ADDENDUM

ADDENDUM NO.: #03

PROJECT: Woodhouse Ford Pro: Building Improvements

PROJECT #: 23043

**FLOOR PLAN -
 LIGHTING - AREA A**

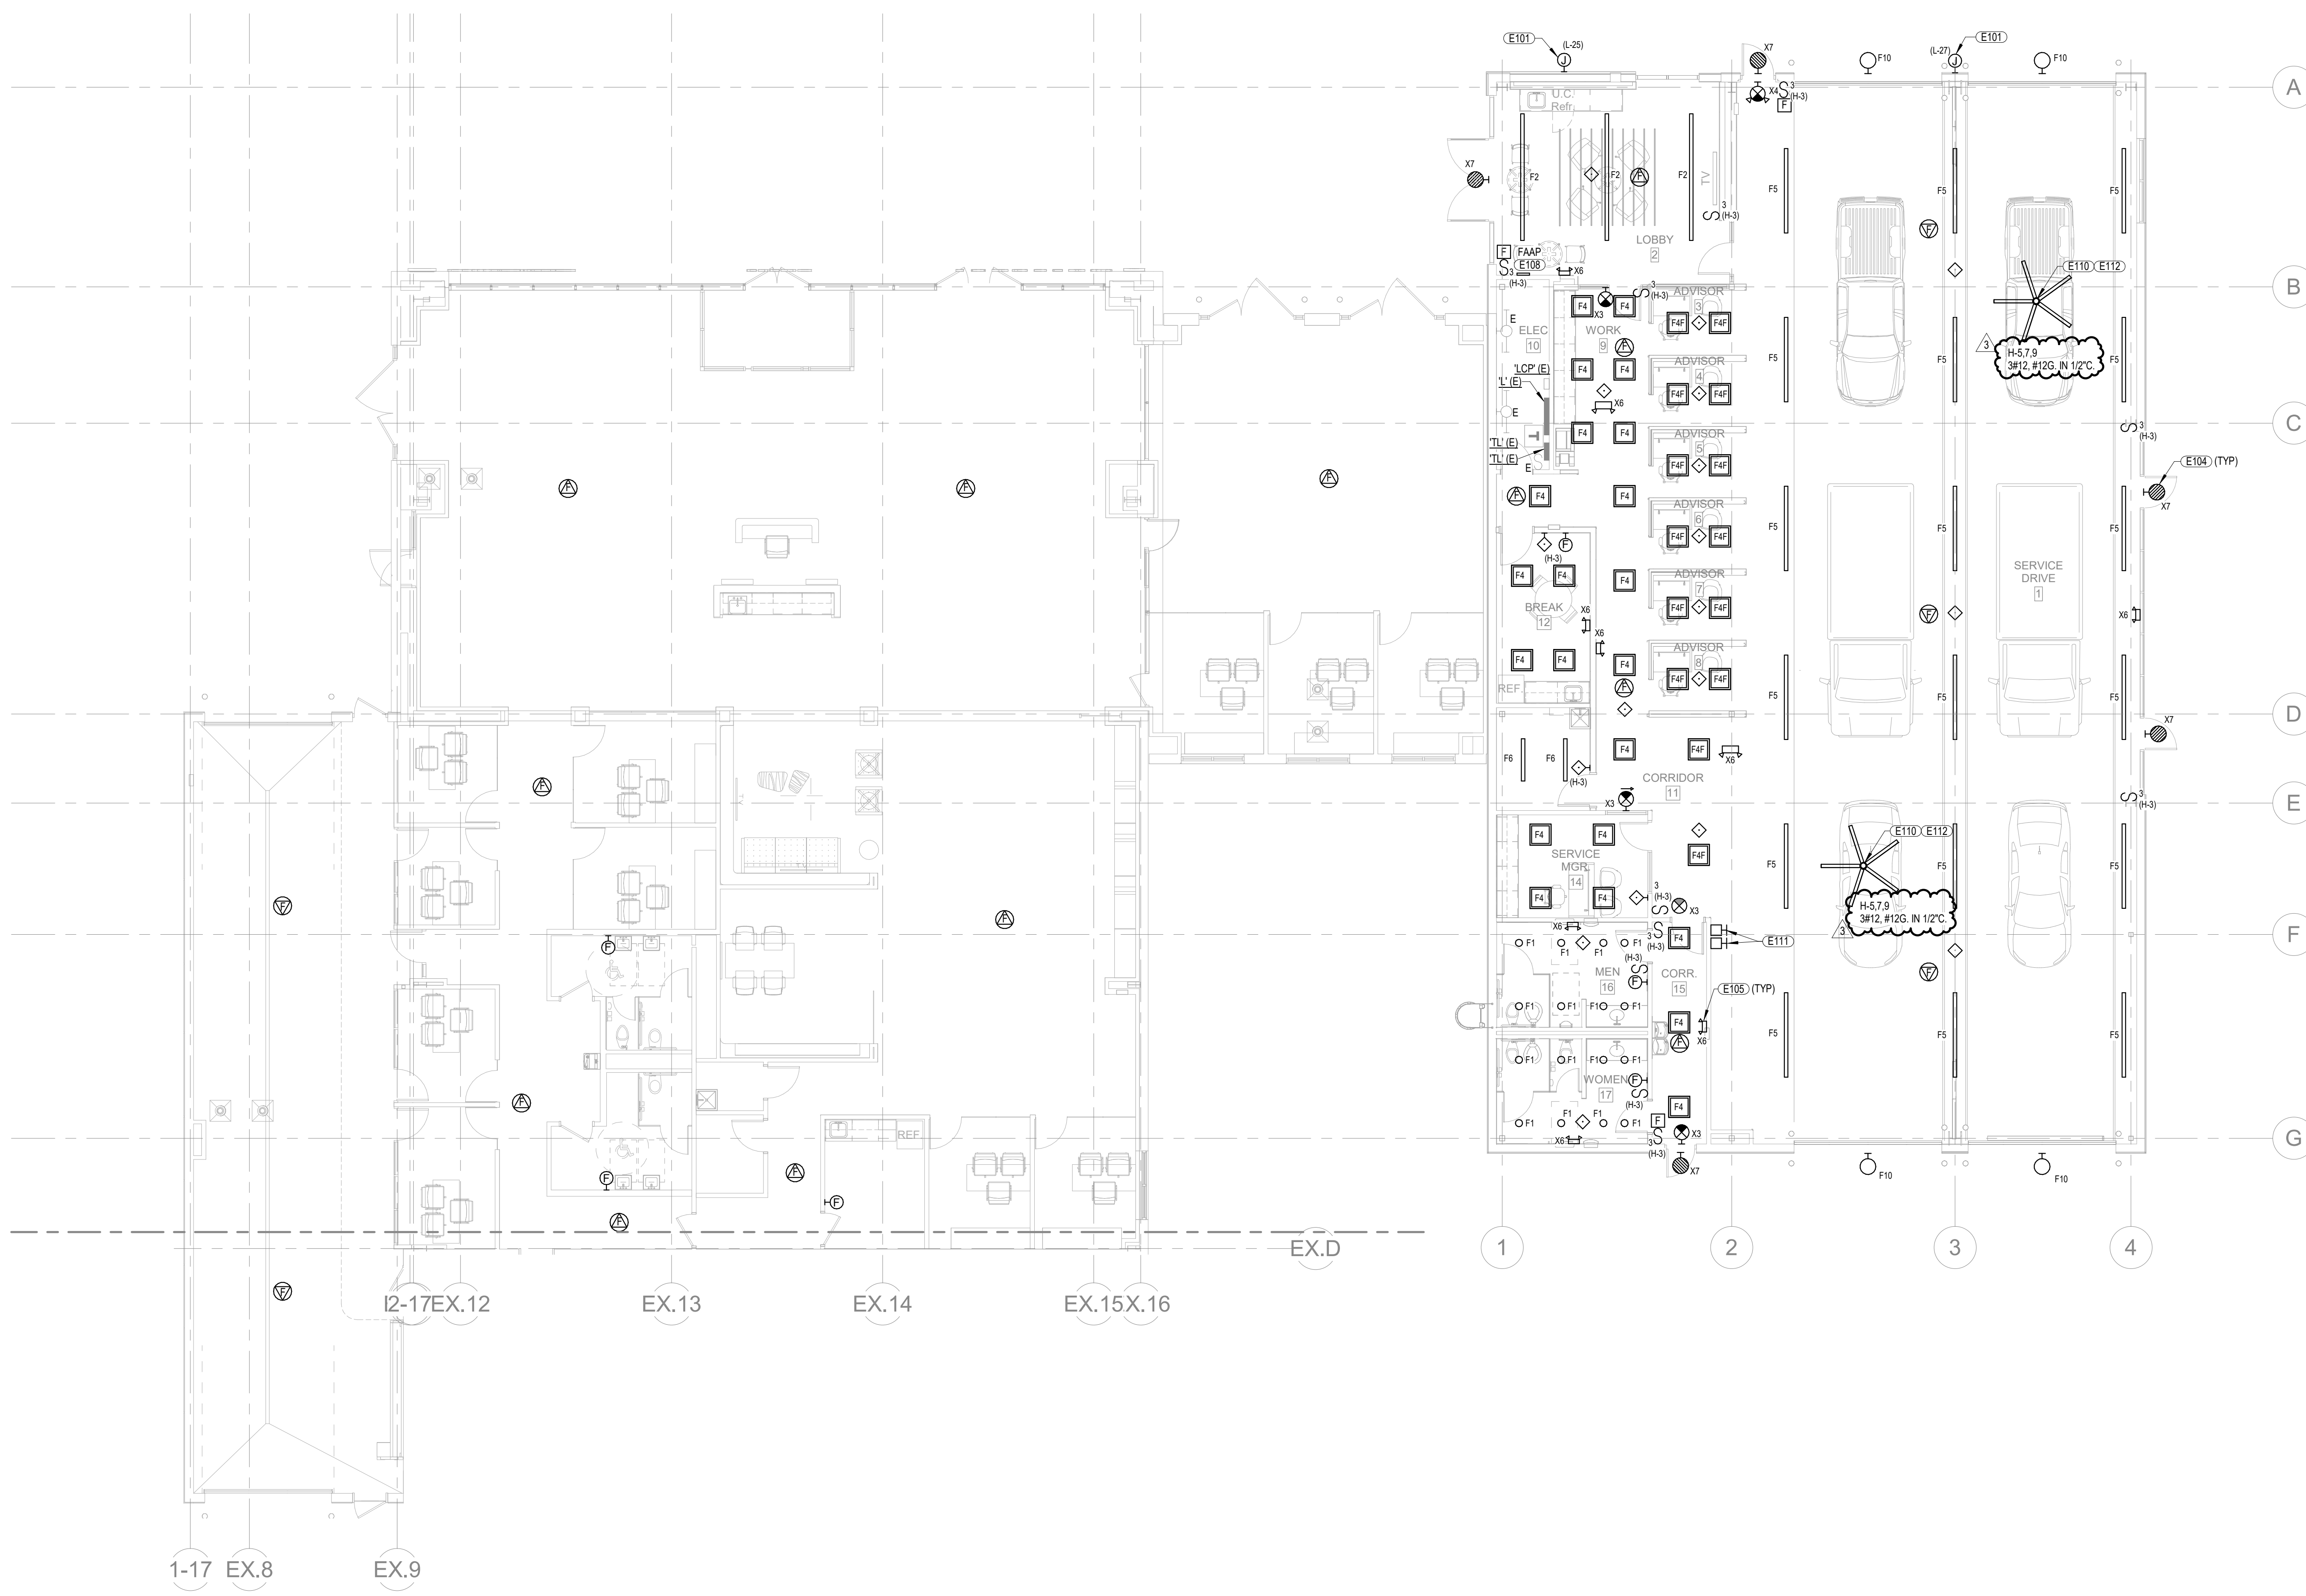
1. Sheet E1.1 – FLOOR PLAN – LIGHTING – AREA A
 - a. Revise HVLS fan circuiting.
2. Sheet E1.2 – FLOOR PLAN – LIGHTING – AREA B
 - a. Revise HVLS fan circuiting.
3. Sheet E1.3 – FLOOR PLAN – LIGHTING – AREA C
 - a. Revise HVLS fan circuiting.
4. Sheet E4.1 – ELECTRICAL PANEL SCHEDULES
 - a. Revise panel schedules.

- a. 3 phase is acceptable. We can update the plans to show this.
- 8. The lead time on the specified switchgear is between 44 and 48 weeks (Siemens and SQ D). Would a 1200 amp panelboard be an acceptable alternative to the switchgear seeing as this project is time sensitive? The current lead time on a 1200 amp panelboard is around 35 weeks and is cheaper than the switchgear option. Please advise if this would be acceptable to quote.
